From: Daniel Thompson <bretmin@gmail.com>
Sent: Tuesday, June 02, 2015 5:34 PM
To: Jennifer Moses
Subject: Re: Kenwood Village LLC

Chad Ronchetti
40 W Cleveland St
Duluth, MN 55811
June 9, 2015

RE: Notice of Public Hearing for Planning Review, Alley Vacation, and Variance for Kenwood Village, Southwest Corner of Kenwood Avenue and Arrowhead Road (PL 15-078, 15-079, and 15-081)

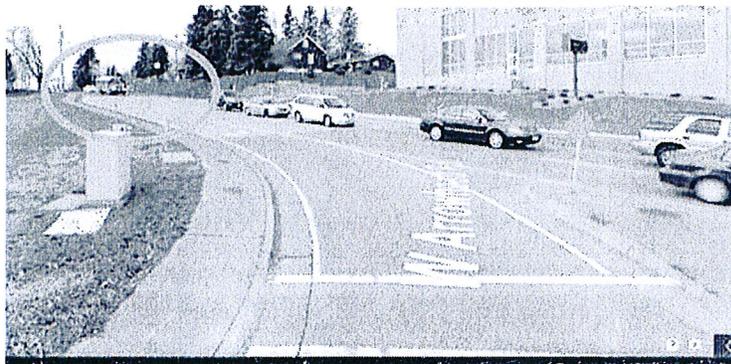
1. When turning right from W Arrowhead. to Kenwood Ave, traffic is given a swipe lane, and the argument for retaining the yield only rights is increased capacity along Arrowhead Rd. This swipe lane is nothing but a danger. It increases potential for pedestrian injury, especially with limited visibility created by the hill (graphic below).

It also allows for higher speeds merging onto Kenwood Ave. High speed merging would be an issue if a traffic light is placed at W Cleveland, and visibility prior to merge would be limited by the proposed 5-story building. Increased capacity is not, in my opinion, a valid argument for retention, as the right lane is currently underutilized and capacity already reduced because the majority of cars merge left at this intersection in anticipation of the reduction in lanes ahead.
